HISTORIC AND DESIGN REVIEW COMMISSION

June 06, 2018

HDRC CASE NO: 2018-238
ADDRESS: 233 MADISON ST
LEGAL DESCRIPTION: NCB 740 BLK 3 LOT N 41.6 FT OF E 100.5 FT OF 19 OR F
ZONING: RM-4, HS
CITY COUNCIL DIST.: 1
DISTRICT: King William Historic District
LANDMARK: Glaeser House #1
APPLICANT: Don Fry
OWNER: Don Fry
TYPE OF WORK: New front yard fence
APPLICATION RECEIVED: May 03, 2018
60-DAY REVIEW: July 02, 2018
REQUEST:

The applicant is requesting a Certificate of Appropriateness for approval to install a new front yard fence.

Property Address:
233 MADISON

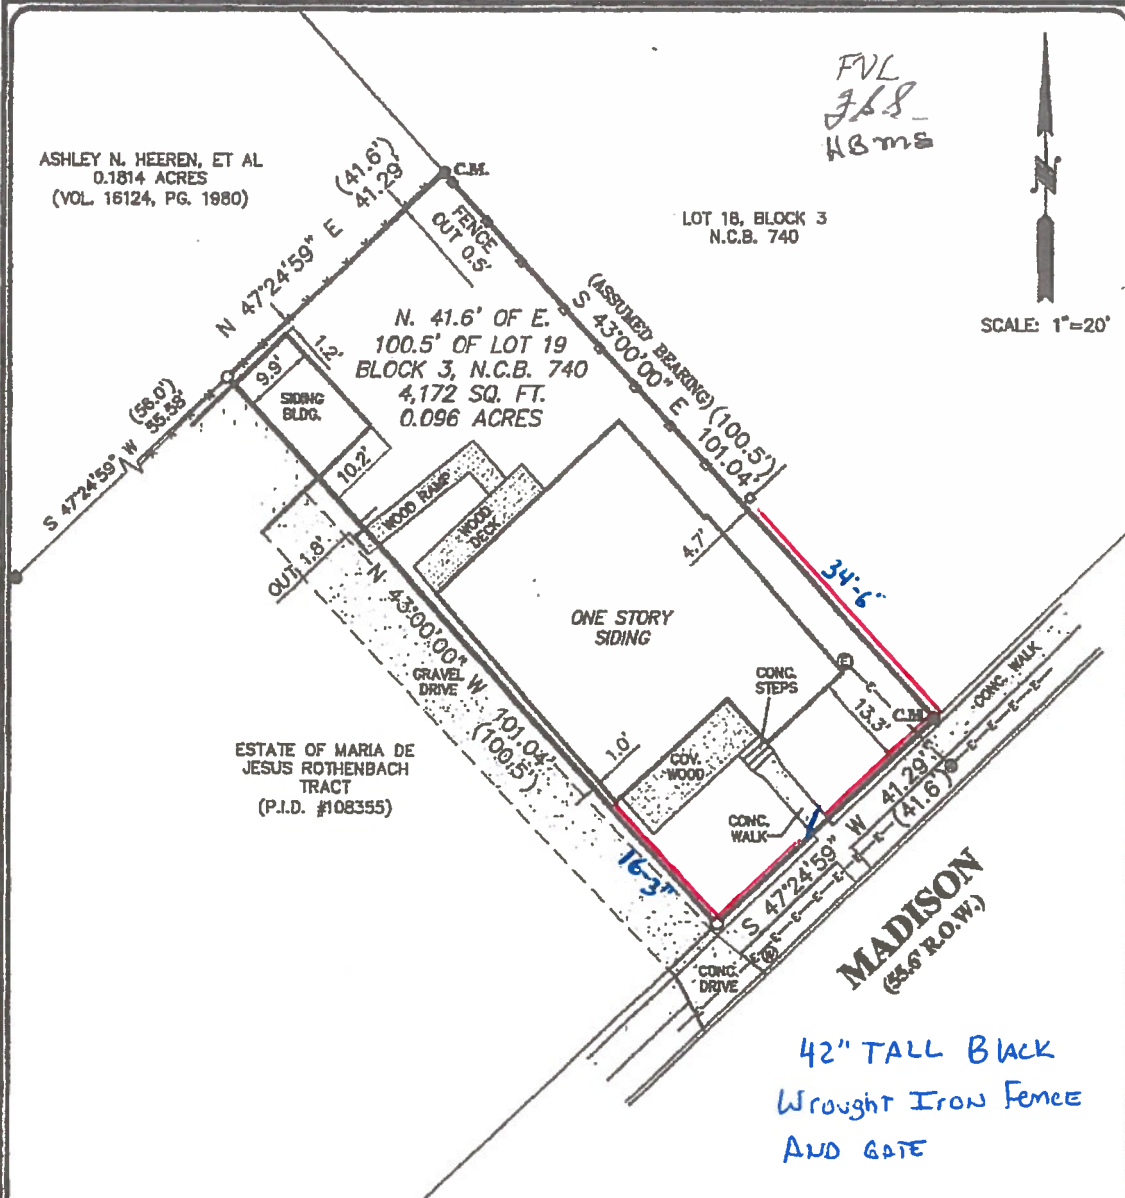
- d. **FENCE LOCATION** - The applicant has proposed to install a wrought iron fence to wrap around the front of the property and turn at the driveway to meet the corner of the structure, as opposed to spanning across with a driveway gate. According to the Guidelines for Site Elements 2.B.ii, new front yard fences should not be introduced within historic districts that did not historically have them. While staff finds that a fence was not currently present on this property, fences are found on Madison and within the Lavaca Historic District. According to the Guidelines for Site Elements 2.C.i., privacy fences should be set back from the front façade to reduce their visual prominence. Staff finds that that proposed location is consistent with the Guidelines. Staff finds that the proposed location of the front yard fence, excluding a front driveway gate, is consistent with the Guidelines.

Staff recommends approval of the fence with the stipulation that no portion exceeds four (4) in height in the front.
